# Technical Memorandum

**Subject:** *989 Somerset Street Residential Development – Transportation Addendum No. 2, Rev. 1*

**Re: 989 Somerset Street**  
**TIA Addendum #2 – Response to City Comments**

**SITE SERVICING PLAN**  
**989 SOMERSET STREET** © DSEL

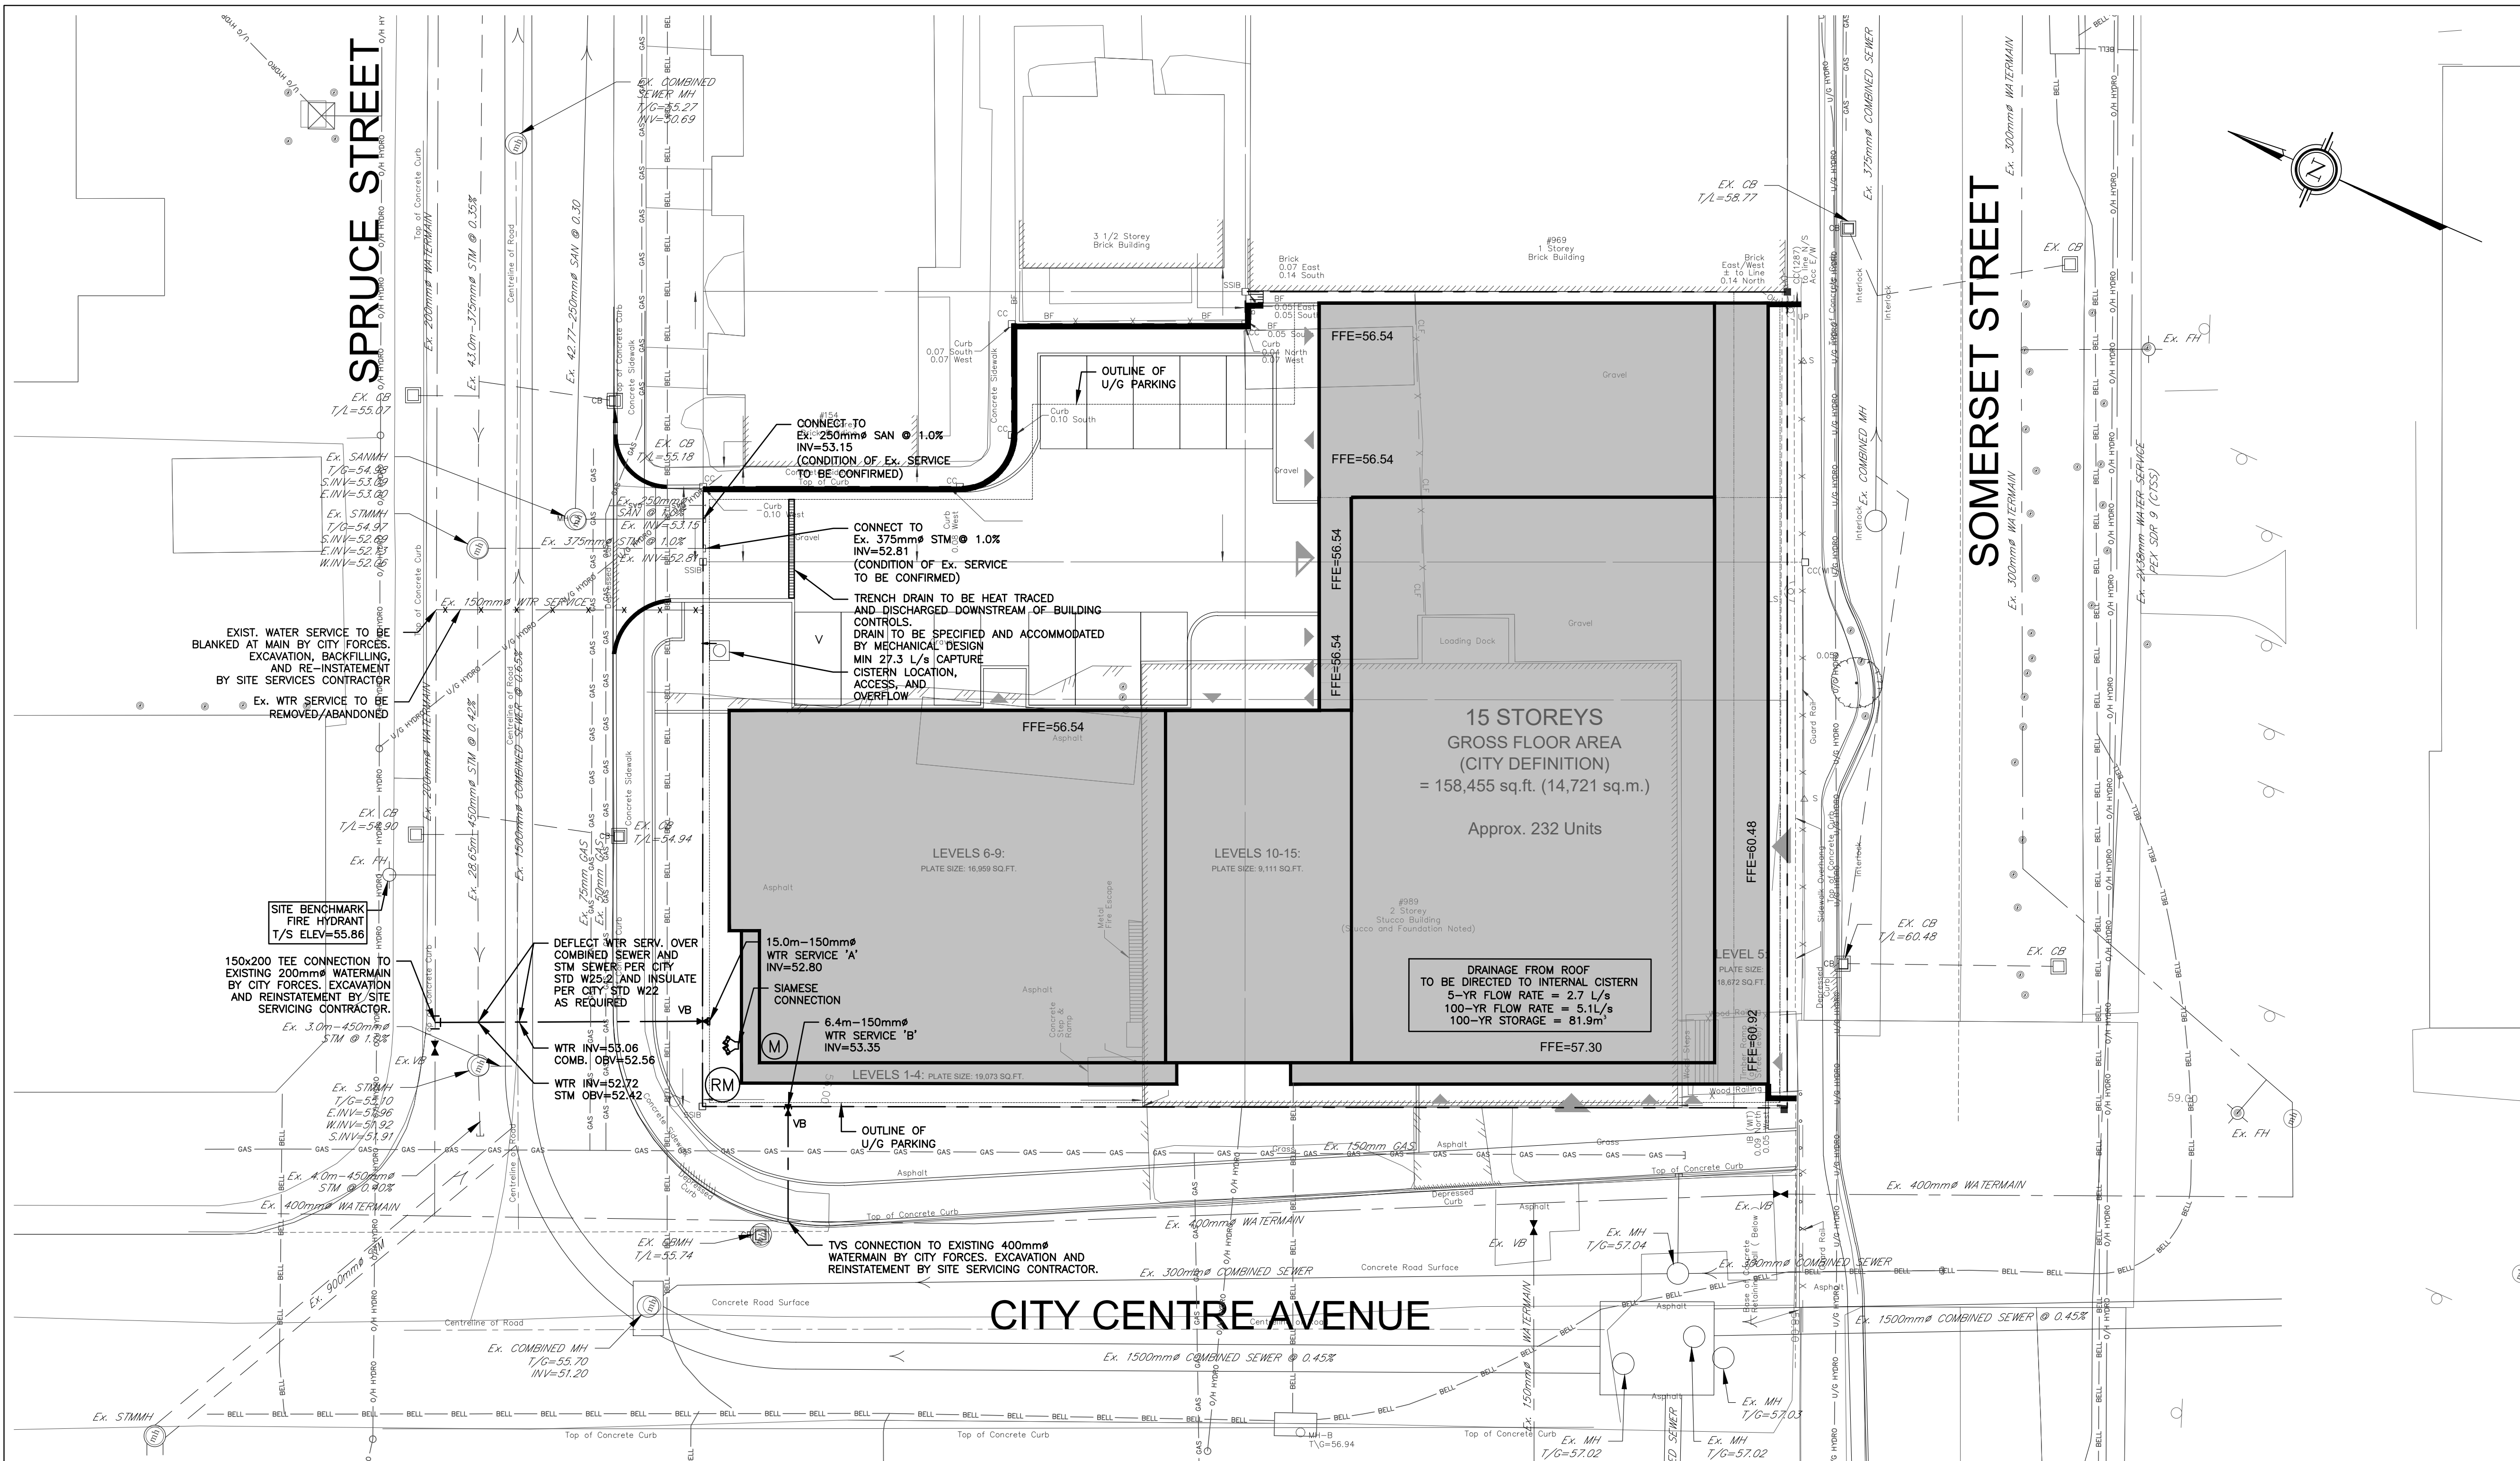
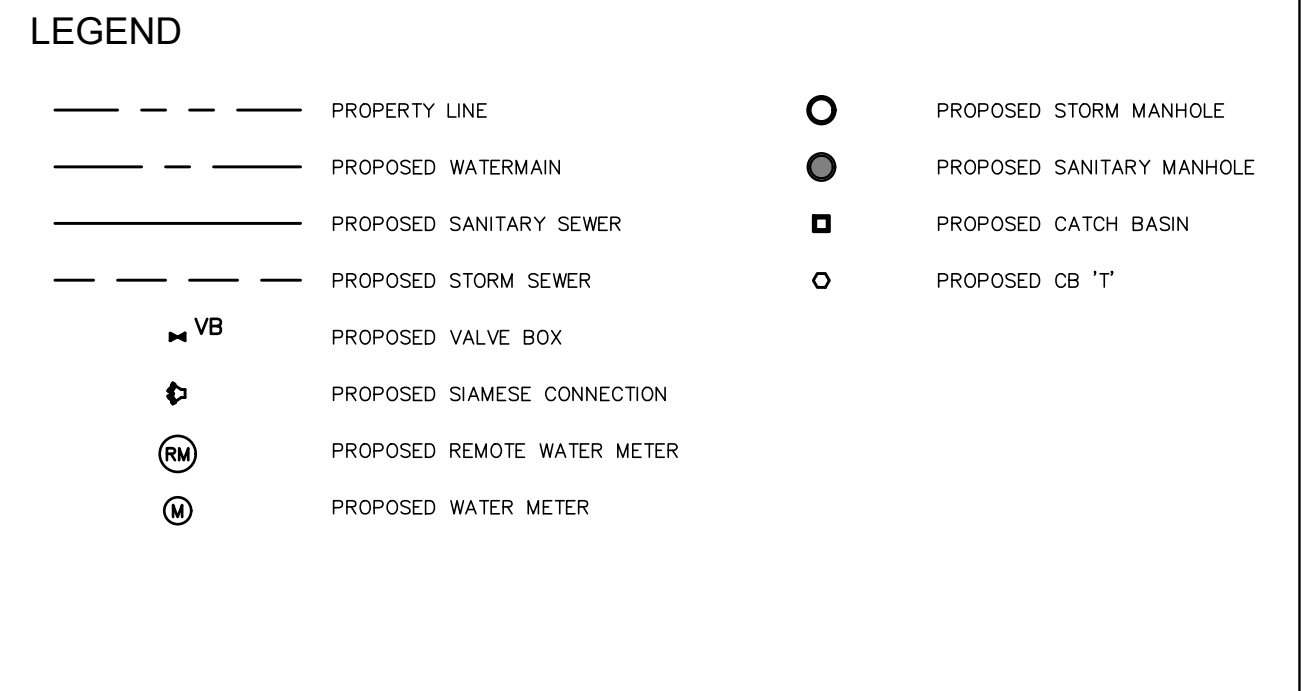
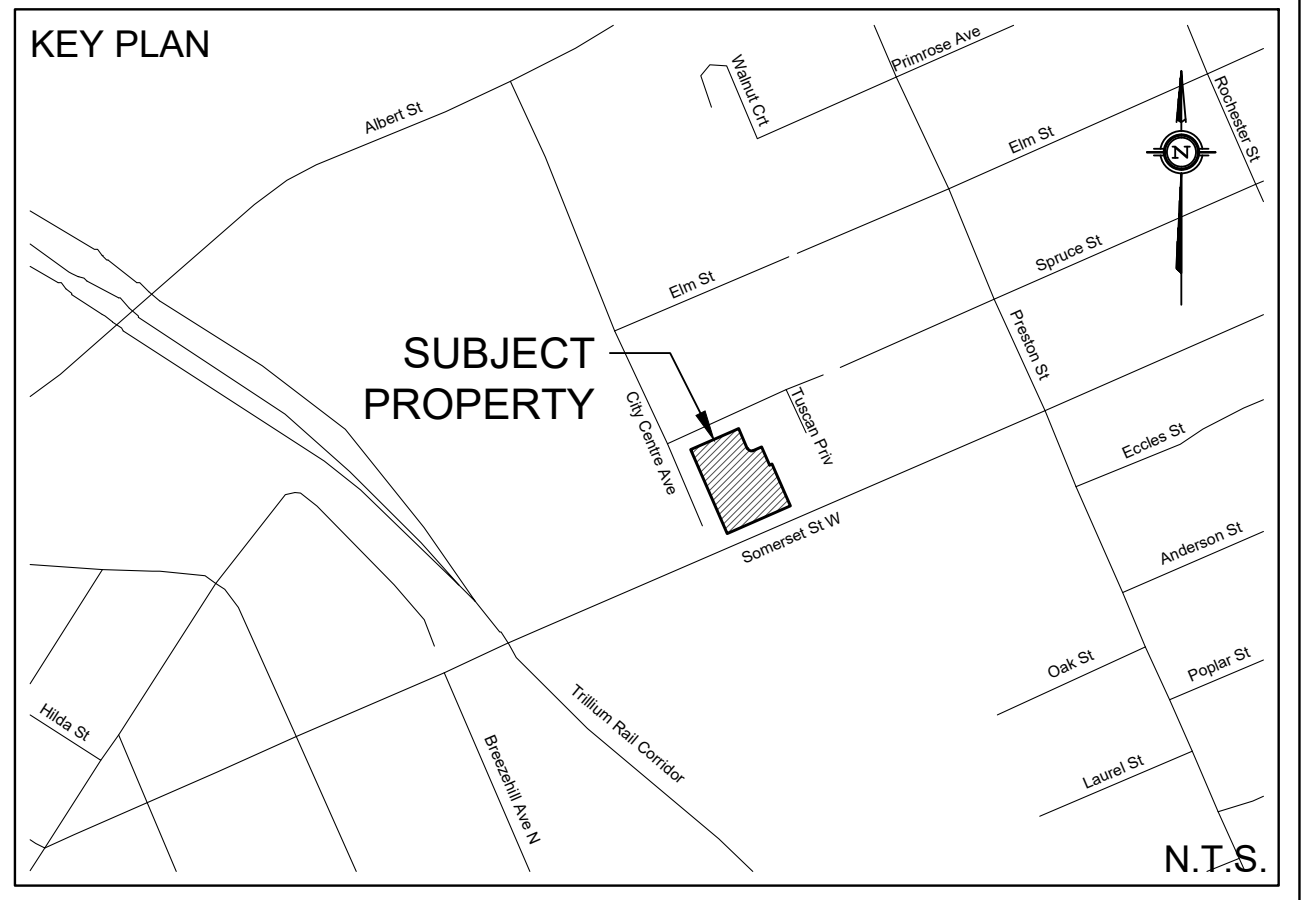
4. Please provide site access grades and ensure compliance with Section 25 (1) (s) and 25 (1) (u) of the Private Approach By-Law. An attached site servicing and grading plan would help alleviate concerns.  
The grading plan indicates that the private approach serving the parking area does not exceed 2% near to the roadway, adhering to Section 25 (1) (s).  
The grading plan also indicates that a 3.5% slope begins approximately 9.8m away from the highway line, which is compliant with Section 25 1 (u).  
Site Servicing and grading plan have been provided as an attachment (Appendix A).
